Building Code of Australia

Assessment Report

**Project Address: Telopea Stage 1A, Lot 5-7 Sturt
Street, Telopea**

Report Number: 200054

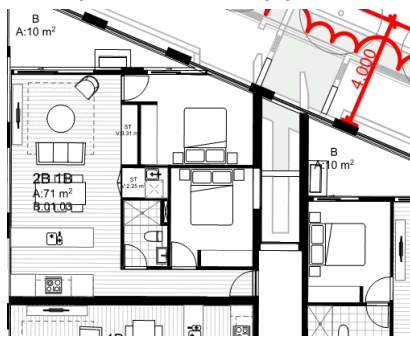
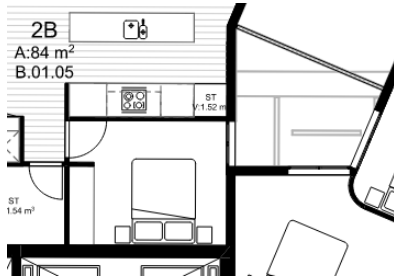
Clause	Performance justification
C3D15 Public corridors in Class 2 and 3 Buildings	The following public corridors exceed 40m without smoke proof walls: Tower B - Upper ground floor Approx. 53 - L2 Approx. 48.2m. Tower D - Upper ground floor Approx. 46m. Tower E - Upper ground floor Approx. 57m - L1 – L8 Approx. 51.4m..

Clause	Performance justification
	 Example of public corridor exceeding 40m
D2D3 Number of exits	The building is required to be provided with a minimum of two exits from each part. The following areas contain only one exit from each storey or part: Basement 01 - Fire Pump Room (B01)  Tower A - The lobby areas (LG -L2)  - Level 8, hot water plant room has only one exit require performance justification. Tower B

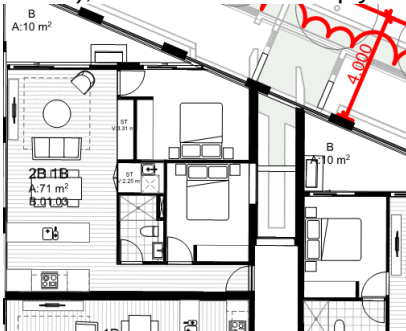
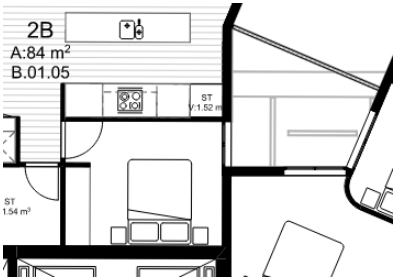
Clause	Performance justification
C3D15 Public corridors in Class 2 and 3 Buildings	The following public corridors exceed 40m without smoke proof walls: Tower B - Upper ground floor Approx. 53 - L2 Approx. 48.2m. Tower D - Upper ground floor Approx. 46m. Tower E - Upper ground floor Approx. 57m - L1 – L8 Approx. 51.4m..  Example of public corridor exceeding 40m
D2D3 Number of exits	The building is required to be provided with a minimum of two exits from each part. The following areas contain only one exit from each storey or part: Basement 01 Fire Pump Room (B01)

Clause	Performance justification
	 Tower A - The lobby areas (LG -L2)  - Level 8, hot water plant room has only one exit require performance justification. Tower B - Level 14 plant area provide with one exit only.  Tower E - Unit E.LG.01 (LG)
